August 30, 2018

**ADDENDUM #2**  
**Chestnut Street Records Center**  
**Building and Site Remodeling**  
**138 West Chestnut Street Lancaster, Ohio 43130**

In accordance with the Construction Documents for the above named Project, this ADDENDUM #2, consisting of page 1- 2 and the following PDF attachments:

## A1.1

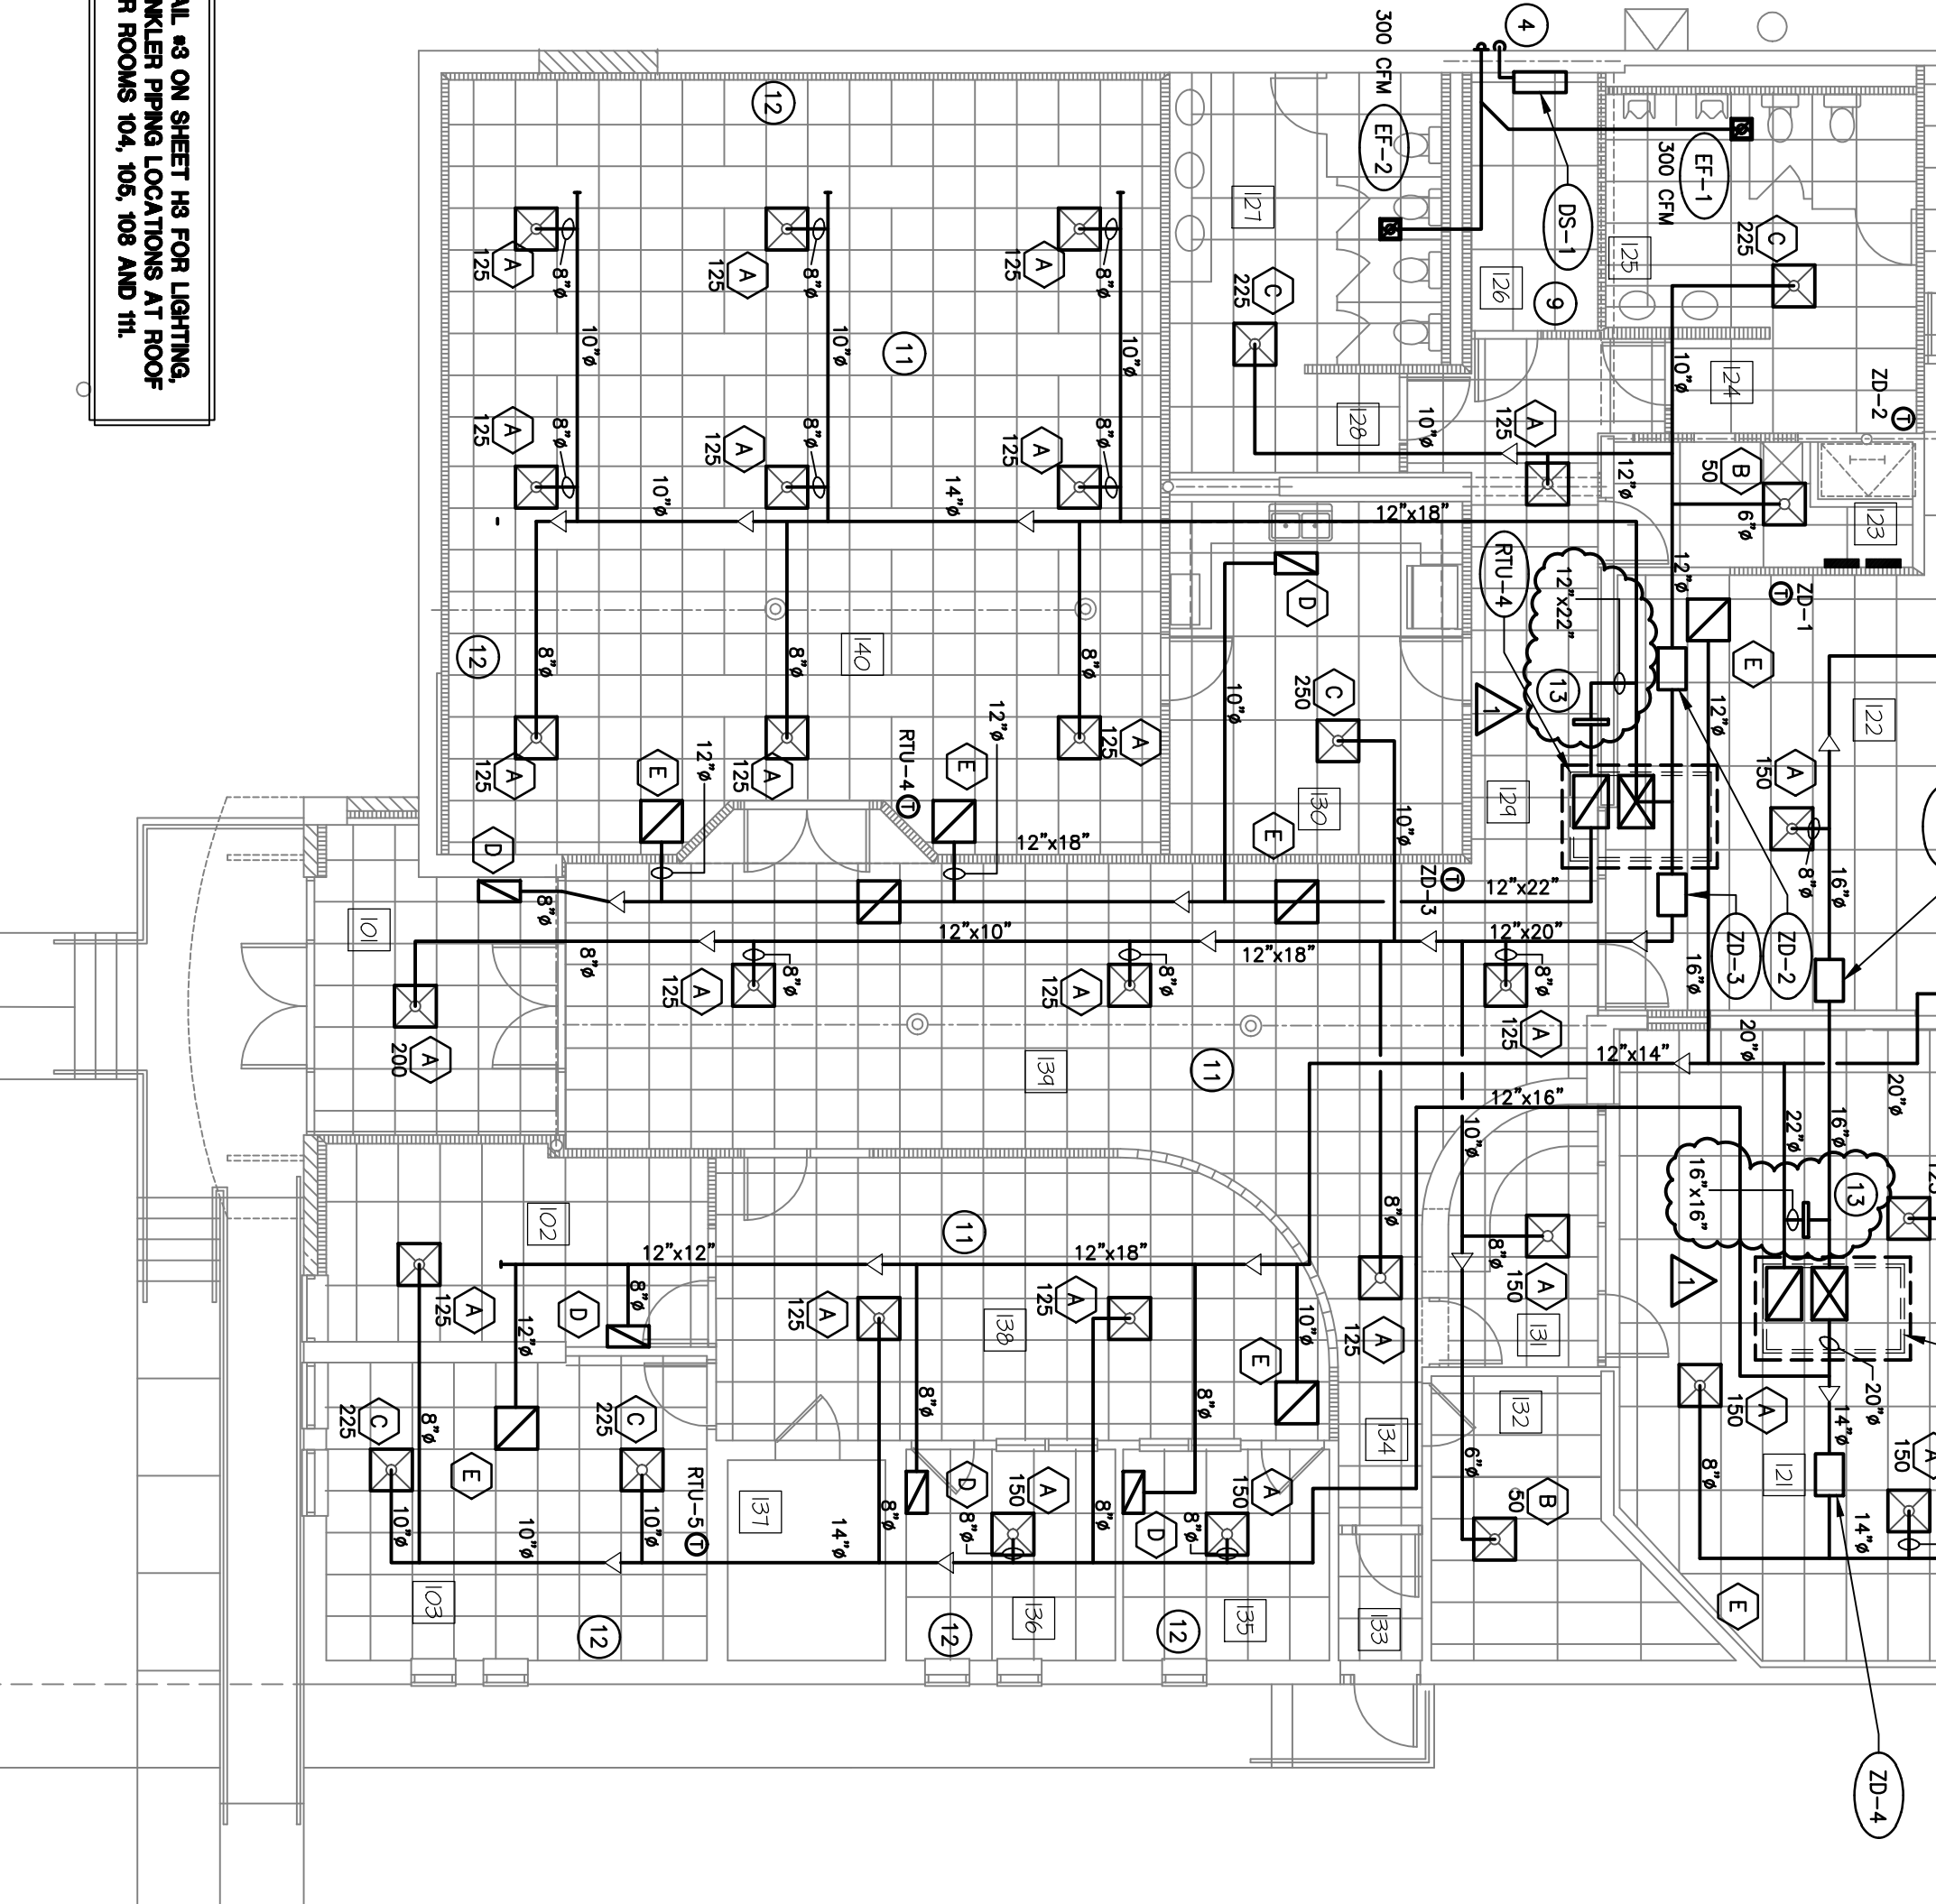
- Item 5.       **SHEETS A1.1 DEMOLITION PLAN AND A2.2 FLOOR PLAN**  
a. When door and frame 108b are demo’d, enlarge existing masonry opening 6” to the east and replace existing lintel per lintel schedule for new 42” wide door as shown on revised plans. Revise door 108b size to ‘3668’ on the door and hardware schedule on sheet a2.2.

**FLOOR PLAN**  
SCALE: 1/8" = 1'-0"

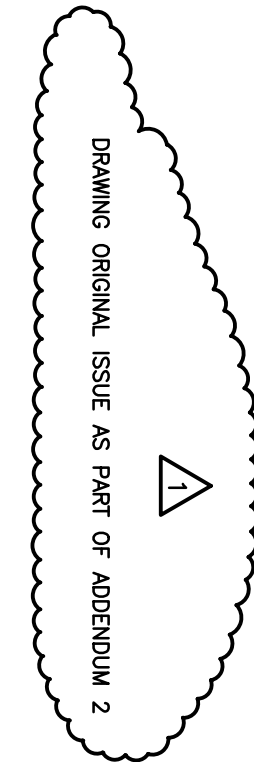
- Item 8.       **SHEET H-1 HVAC FLOOR PLAN**  
a. Add gravity damper controlled bypass ducts for RTU-4 and RTU-5.  
b. Add coded notes for bypass duct and dehumidifier drain piping.

c. Remove references to Dynamix Software and change descriptions to ‘BAS’.
- Item 9.       **SHEET H-4 HVAC SCHEDULES**  
a. Add stainless steel heat exchanger to RTU-4.  
Add notes for control systems interface with BAS.

12. DEMISH ALL EXISTING BASEBOARD ELECTRICAL HEATERS.
13. BYPASS DUCT WITH COUNTERBALANCED BACKDRAFT DAMPER (RUSKIN CB02 OR EQUIVALENT). SET TO OPEN AT 0.60 Wg BACK PRESSURE.
14. ROUTE 3/4" PVC PIPE TO EXTERIOR WALL FOR DEHUMIDIFIER CONDENSATE REMOVAL. FINISH 1/2" TIE ADAPTOR AT DEHUMIDIFIER OUTLET. ROUTE PIPE DOWN INTERIOR SIDE OF EXTERIOR WALL AND PENETRATE 1"-0" ABOVE GRADE. THEN TURN THE PIPE DOWN AND TERMINATE A MAXIMUM OF 6" ABOVE GROUND. INSULATE PIPE AFTER PENETRATION.
